DEVELOPMENT REVIEW COMMITTEE (DRC) COMMENT REPORT

Project Name: 353 Sunset, LLC / 353 Sunset Drive Residences

Case Number: R15008

Request: Site Plan Level III Review: Eight (8) Multi-Family Units

Scale:	1"= 10'	Date	01/16/15
Job No.	14-1118.00	Plot Date	01/16/15
Drawn by	DTR	Sheet No.	C1
Proj. Mgr.	DTR		
Appr. by	JMF	1 of 4

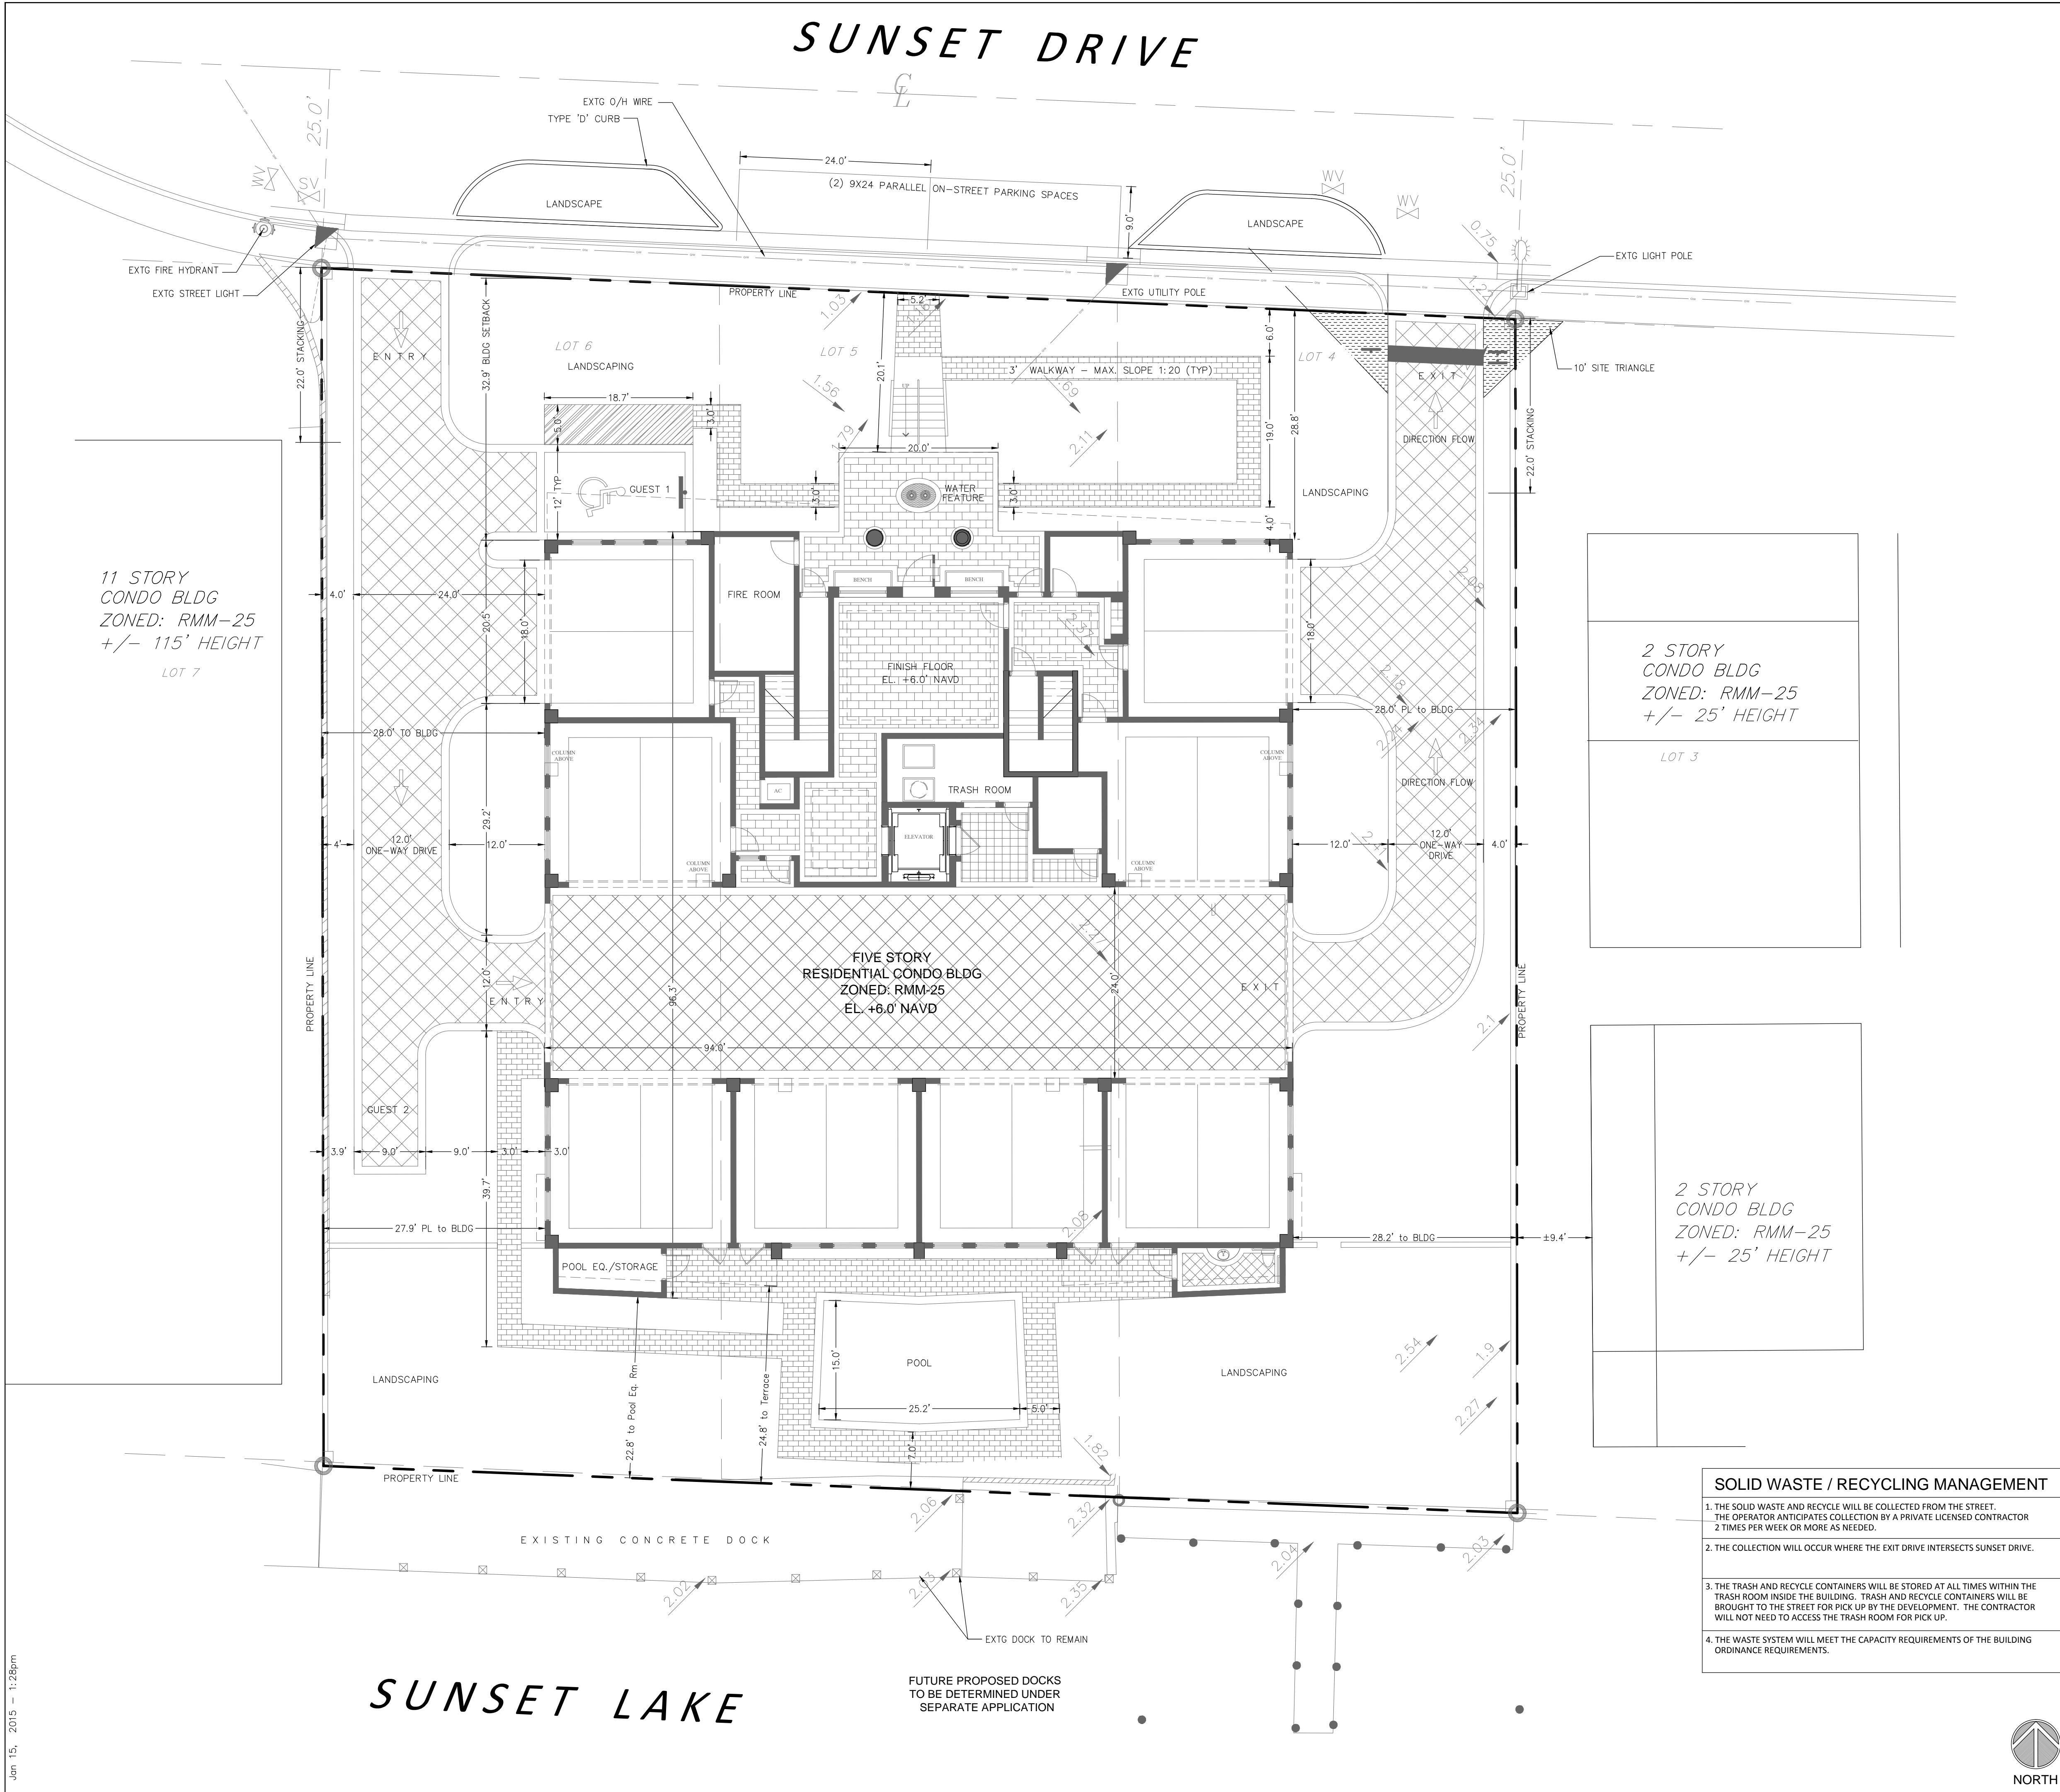
2. Page C1 – survey notes conflict with Survey Page (notes 6, 7 , 8 that are correct)
3. Plans shall show :
 - Type of Construction - _____
 - Type of Occupancy Group - _____
